# LARAMIE COUNTY PLANNING & DEVELOPMENT DEPARTMENT

**TITLE:** Review and action on a Zone Change and a Subdivision Permit & Plat for Westedt Meadows, 1<sup>st</sup> Filing, located in a portion of land situated in the NW1/4 Section 21, T14N, R65W, of the 6th PM, Laramie County, WY.

**WESTEDT MEADOWS  
1ST FILING**

**PZ-19-00140(143) Westedt Meadows, 1<sup>st</sup> Filing Zone Change and Sub Pmt & Plat**

FINAL PLAT  
FOR  
WESTEDT MEADOWS  
BEING SITUATED IN A PORTION OF THE NORTHWEST 1/4  
SECTION 21, T14N, R65W,  
OF THE 6TH PRINCIPAL MERIDIAN,  
LARAMIE COUNTY, WYOMING  
PREPARED MAY 2019

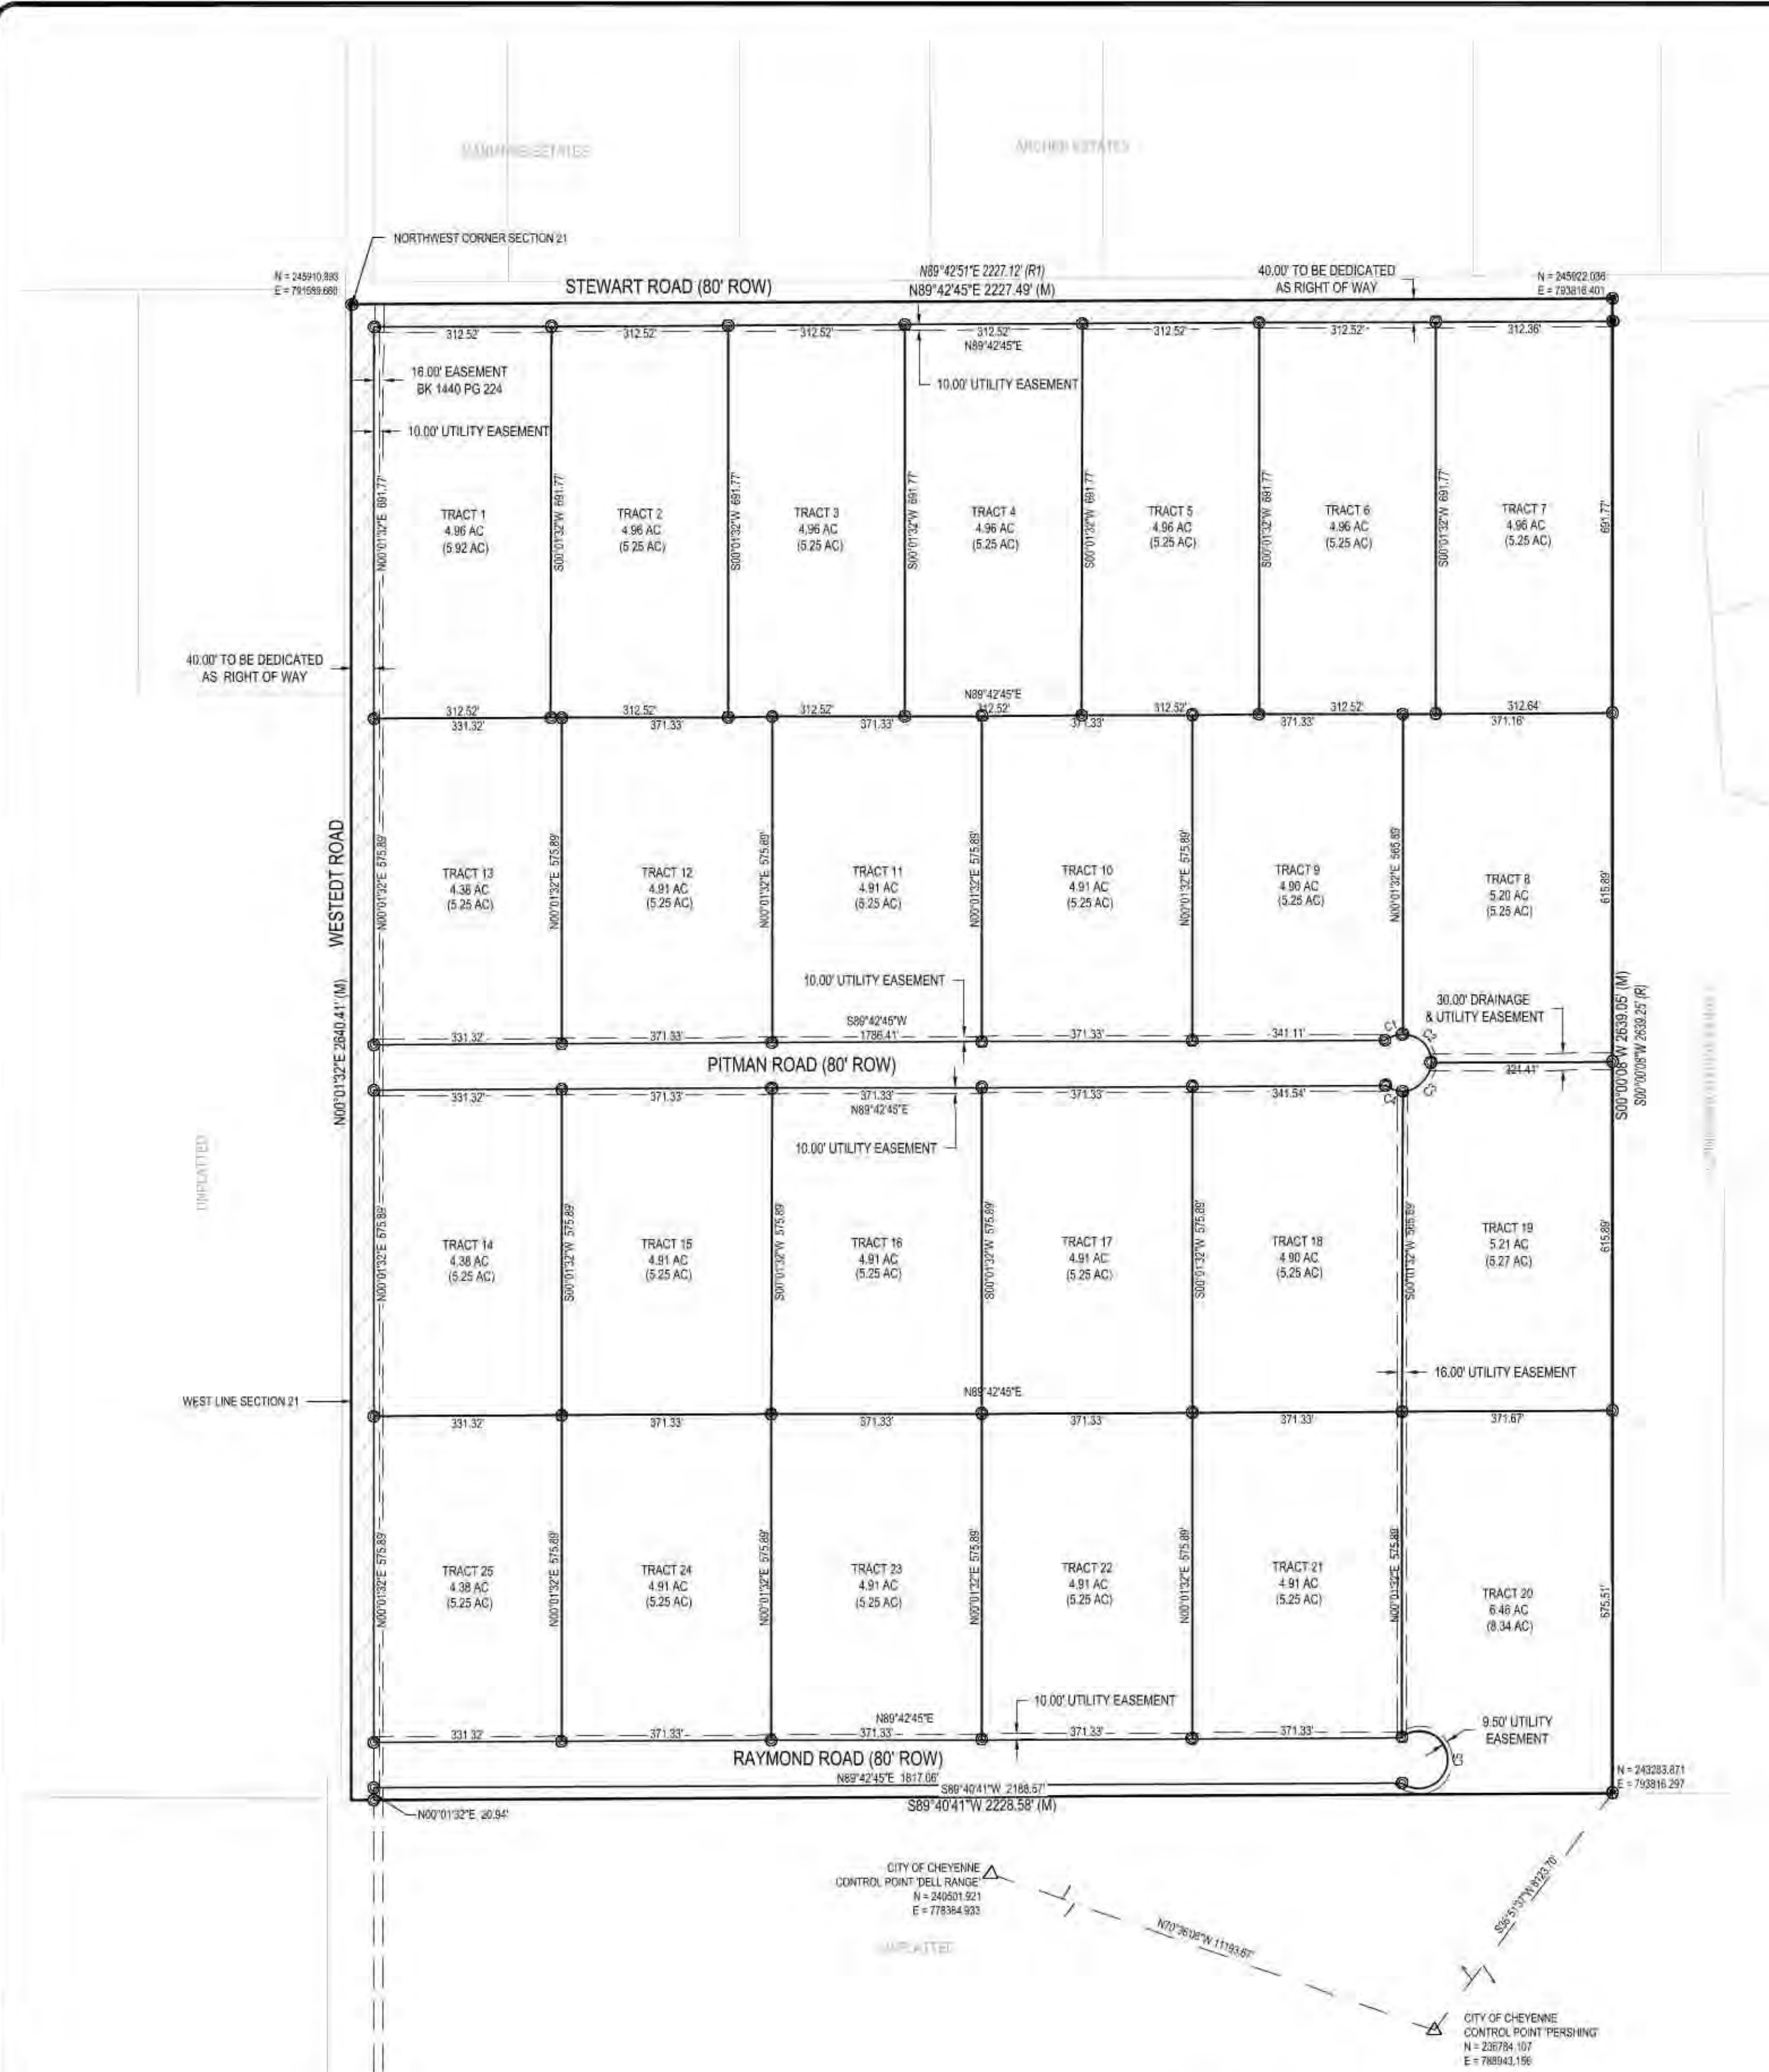
1. Access for all lots shall be via interior roadways and Stewart Road. No access shall be allowed off of Westedt Road. A note should be added to the plat drawing stating this.
2. On the plat drawing, the Title Block indicates that the subdivision is located in the SOUTHWEST  $\frac{1}{4}$  of Section 21 but the Legal Description indicates that it is located in the NORTHWEST  $\frac{1}{4}$  of Section 21. I believe the Legal Description is the correct one and the Title Block needs to be changed.
3. I concur with the request for a waiver of a detailed Drainage Study based on the information provided.
4. The Traffic Study submitted is adequate for this development and I concur with its findings.

1. The NORTHWEST CORNER of Section 21 is called out as the POINT OF BEGINNING and therefore probably should be labeled on the drawing. It would be helpful if the WEST Boundary of Section 21 was also labeled on the drawing. From the regulations - "For the purposes of enhancing the City and County GIS Program framework, all public land survey corners on or within the subdivision boundary shall have field observation coordinates provided on the plat".

2. The State Plane Coordinate conversion note in the BASIS OF BEARINGS is a little unclear. The first part of the note indicates "TO CONVERT TO STATE PLANE COORDINATES ADD 200,000 FT TO THE NORTHING AND 700,000 FT TO THE EASTING.....". The EXAMPLE POINT conversion example does not seem to follow those instructions.

3. Some of the bearing and distance labels on the drawing are labeled with lines through them and are difficult to read, it would be easier to read if the lines were blocked out or the labels were moved.

4. The 10' UTILITY EASEMENTS ABUTTING ALL ROADWAY RIGHT OF WAYS is mentioned in the NOTES, however all but one of those easements is also dimensioned on the drawing. The 10' UTILITY EASEMENT along the South Boundary of PITTMAN ROAD is not dimensioned.

5. WESTEDT ROAD is labeled as having an 80' Right of Way but only the East Right of Way Boundary is shown on the drawing.
6. If one were to add some information such as, at a minimum, the Section, Township and Range data with enough detail to indicate the location of the subdivision within the Section.

Tract 20 cannot be reached with utilities by easement since the utility easement does not shown extended around the cul-de-sac. Utilities will need to be in ROW which is not ideal. Can this be updated to show the 10 ft utility easement around the cul-de-sac?

1. Access for all lots shall be via interior roadways and Stewart Road. No access shall be allowed off of Westedt Road. A note should be added to the plat drawing stating this. **Any Access off of Westedt Road will meet County Requirements.**
2. On the plat drawing, the Title Block indicates that the subdivision is located in the SOUTHWEST ¼ of Section 21 but the Legal Description indicates that it is located in the NORTHWEST ¼ of Section 21. I believe the Legal Description is the correct one and the Title Block needs to be changed. **Noted and changed on Plat**
3. I concur with the request for a waiver of a detailed Drainage Study based on the information provided. **Noted**
4. The Traffic Study submitted is adequate for this development and I concur with its findings. **Noted**

1. The NORTHWEST CORNER of Section 21 is called out as the POINT OF BEGINNING and therefore probably should be labeled on the drawing. It would be helpful if the WEST Boundary of Section 21 was also labeled on the drawing. From the regulations - "For the purposes of enhancing the City and County GIS Program framework, all public land survey corners on or within the subdivision boundary shall have field observation coordinates provided on the plat". **Noted and changed on Plat.**

2. The State Plane Coordinate conversion note in the BASIS OF BEARINGS is a little unclear. The first part of the note indicates "TO CONVERT TO STATE PLANE COORDINATES ADD 200,000 FT TO THE NORTHING AND 700,000 FT TO THE EASTING.....". The EXAMPLE POINT conversion example does not seem to follow those instructions. **Noted and changed on plat.**

3. Some of the bearing and distance labels on the drawing are labeled with lines through them and are difficult to read, it would be easier to read if the lines were blocked out or the labels were moved. **Noted and Changed on Plat.**

4. The 10' UTILITY EASEMENTS ABUTTING ALL ROADWAY RIGHT OF WAYS is mentioned in the NOTES, however all but one of those easements is also dimensioned on the drawing. The 10' UTILITY EASEMENT along the South Boundary of PITTMAN ROAD is not dimensioned. **Noted and Changed on Plat.**

5. WESTEDT ROAD is labeled as having an 80' Right of Way but only the East Right of Way Boundary is shown on the drawing. **Noted. Labeled the 40' ROW dedicated with this Plat. West Side not platted.**

6. If one were to add some information such as, at a minimum, the Section, Township and Range data with enough detail to indicate the location of the subdivision within the Section. **Noted and Changed on Plat.**

**This cul-de-sac will be eliminated and a road connection to the south at this location in the second filing. Therefore, we don't want to plat the easement and then vacate it in the second filing.**
